REMARKS

In the Office Action dated August 23, 2004, claims 1- 20 are pending and all claims are rejected. Reconsideration is requested for at least the reasons discussed hereinbelow.

Amendments to the Drawings

FIG. I

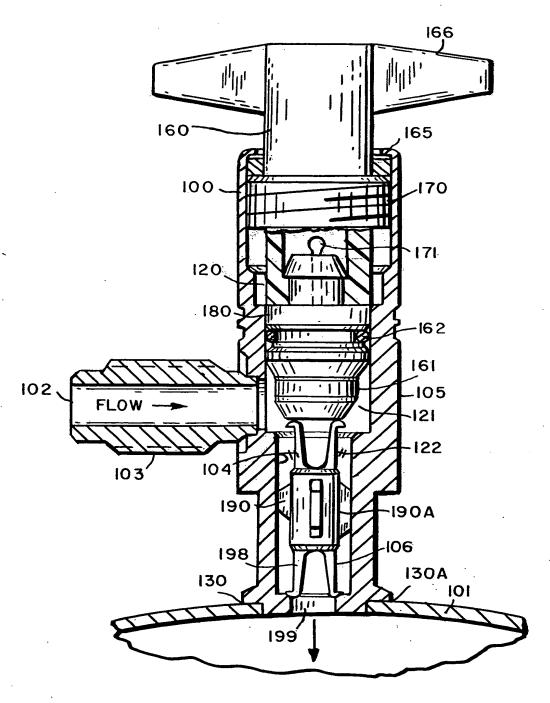
Objection is made to the Drawings for reasons stated by the examiner. An amendment to Figures 1, 2, 3, 4, 5 and 16 is submitted herewith to correct inconsistencies between the specification and the Drawings. It is respectfully submitted that the proposed amendment renders the objection moot. Entry of the replacement pages of drawings is requested.

Please amend Figures 1, 2, 3, 4, 5 and 16 as marked in red on copies of the repalcement drawing pages and enter the replacement pages of drawings.
